**From:** [Stephen Ubl](#)  
**To:** [Marcia Moermond](#)  
**Cc:** [Nathan Bruhn](#)  
**Subject:** FW: 733 Fairview Ave. N.  
**Date:** Monday, March 11, 2024 1:04:54 PM  
**Attachments:** [image005.png](#)  
[image006.png](#)  
[image007.png](#)  
[image008.png](#)  
[image009.png](#)  
[image010.png](#)

Below is an email from the owner. The information provided by him does not reflect the material installed in the home at 733 Fairview Ave N. My inspectors took the time to go to Menard's and communicate with his contact, retrieve the correct material information, and affirm that the correct material in the home was installed per manufacture's recommendations.

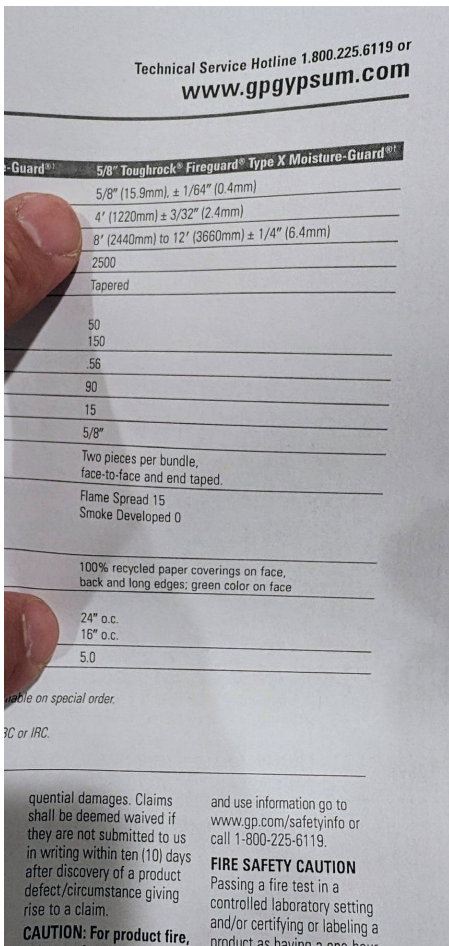
To this end, as illustrated in the Georgia-Pacific manufacturer's installation recommendation instructions for the 5/8" Toughrock Fireguard ("green" board) Type X Moisture Guard gypsum sheetrock that has been installed in the 733 basement ceilings, Framing Spacing, Maximum for Ceilings is **16" o.c., not 12" o.c.**

To this end, the basement 5/8" ceilings at the 733 Fairview Ave. N. property remain in compliance with both the CertainTeed ("purple" board) and the Georgia-Pacific ("green" board) manufacturer's installation recommendations of a minimum of 16" o.c.

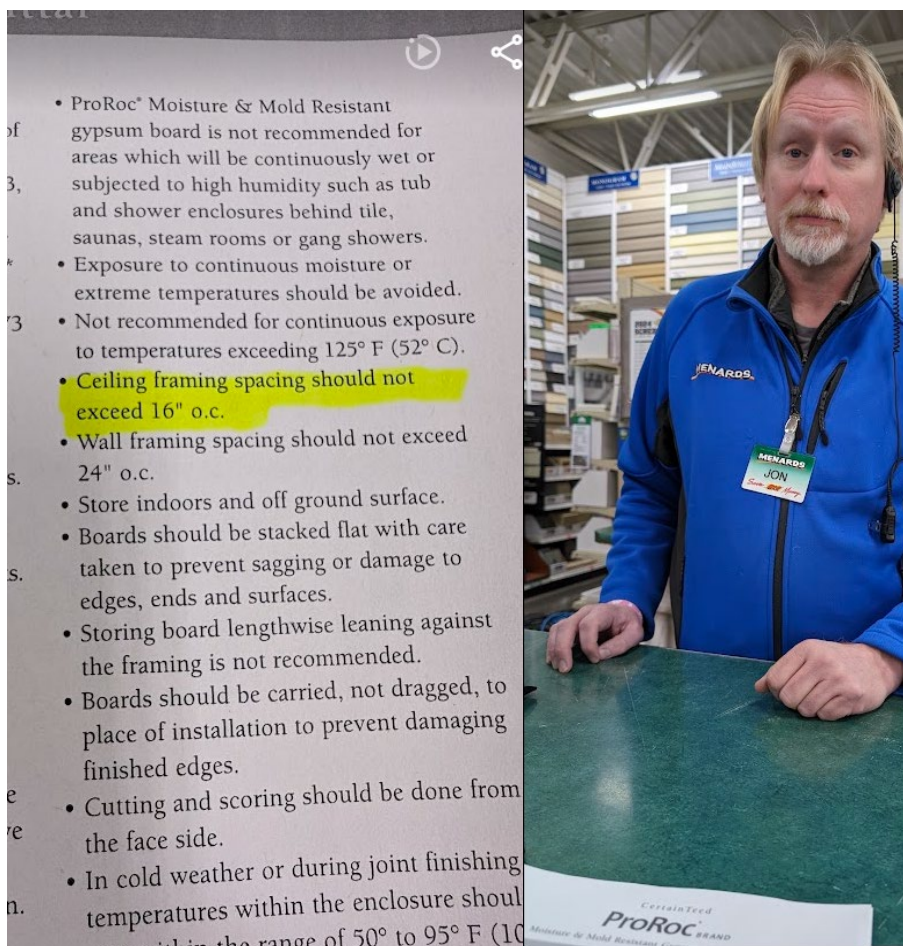
Tuesday, after our meeting, I went to Menards. I eventually was able to speak with Jon, in the building center, who is familiar with my situation. I asked him to provide me with the literature on the manufacturer's installation instructions for the moisture-mold-resistant sheetrock to determine whether what I did in my home complied with the manufacturer's installation recommendations. I asked him specifically whether the moisture & mold resistance gypsum board he sold me from Menards to install on many of the walls and ceilings, per the manufacturer's instructions, called for it to be installed on 16" on center or whether it required a lesser distance. Without saying a word, Jon got on his screen, printed, and with his yellow highlighter, marked the following and slid the paper over to me: **"Ceiling framing spacing**

should not exceed 16" o.c." Based on the above, I complied with the manufacturer's gypsum board moisture-mold-resistant installation recommendations, Stephen.

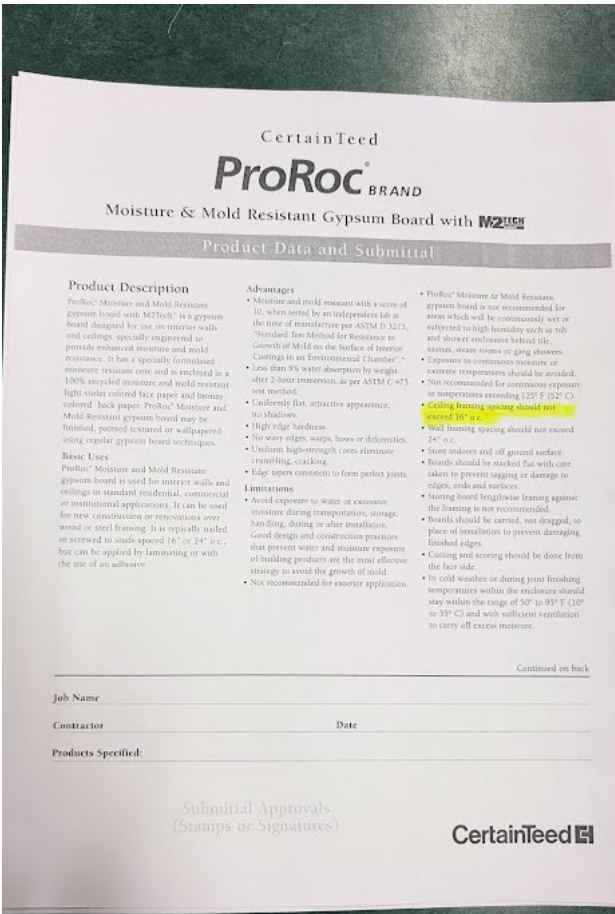
Next, I am sharing with you a series of photos that illustrate the 3 bathrooms in the 733 Fairview Ave. N. home: 1) Main Floor bathroom; 2) Upstairs bathroom; and, 3) Basement bathroom. As I discussed with you, all three bathrooms are entirely done with cement board. In fact, there are additional areas in the home that have cement boards as well. For instance, there is cement board in the Main Floor front entryway, in the Main living room, in the kitchen, in the utility room, in the upstairs landing area, and covering all the flooring areas in the Upstairs and the Main floor.
